# 1. COA-041237-2018

511 North 21<sup>st</sup> Street

Union Hill

## STAFF REPORT

Figure 1. 1925 Sanborn Map

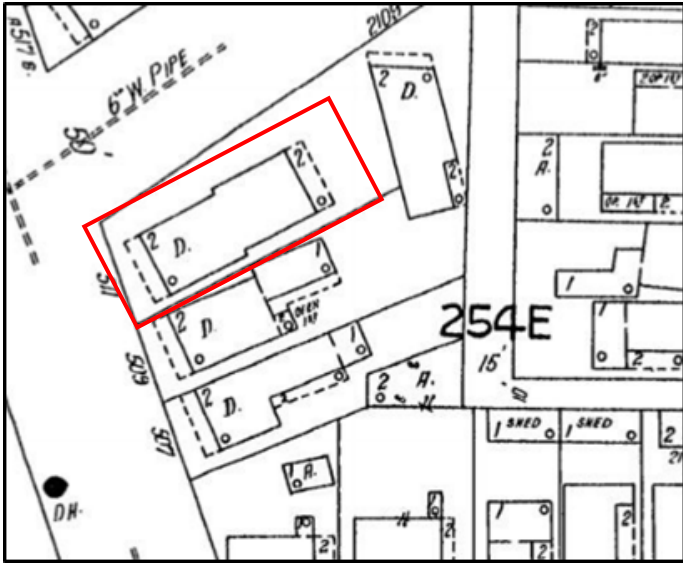
Pg. 59, #7	<i>Use available documentation when reconstructing missing elements. Pictorial, historical or physical documentation can be helpful.</i>	Sanborn maps indicate that a 2-story rear porch was added to the home sometime before 1925 (see Figure 1). Though staff was unable to locate pictorial evidence of the rear porch, tax assessment records from 1934-1956 and 1957-1977 indicate that the rear porch was 21' wide and 6' deep (see Figures 2, 3).
Pg. 71, #5	<i>Porch replacements should match the original as much as possible.</i>	As the two-story porch is designed to replicate historic features, <u>staff recommends the porch depth be reduced to 6 feet, to match the missing porch.</u> Staff also notes that the proposed porch is not centered on the rear elevation, as the historic porch was. <u>Staff recommends the porch be centered on the rear wall.</u>
Pg. 71, #4	<i>Front and side porches are architecturally more ornate than utilitarian back porches.</i>	The proposed new porch will have 8" square cement board wrapped columns with decorative capitals. As back porches within the historic district are typically utilitarian, <u>staff recommends the design of the columns be simplified, details to be submitted to staff for administrative review.</u>

- The porch depth be reduced to 6 feet, to match the missing porch, or the design of the structure be altered so it does not appear to replicate a historic porch, the design to be reviewed and approved by staff.
- The porch be centered on the rear wall.
- The design of the columns be simplified, details to be submitted to staff for administrative review.
- The screening be installed on the interior of the railings and columns to maintain the open appearance of the porch.
- The existing door opening on the first story in the rear be maintained at its current size.
- New windows and doors be wood or aluminum clad wood with simulated divided lites to include interior and exterior muntins and a spacer bar between the glass.
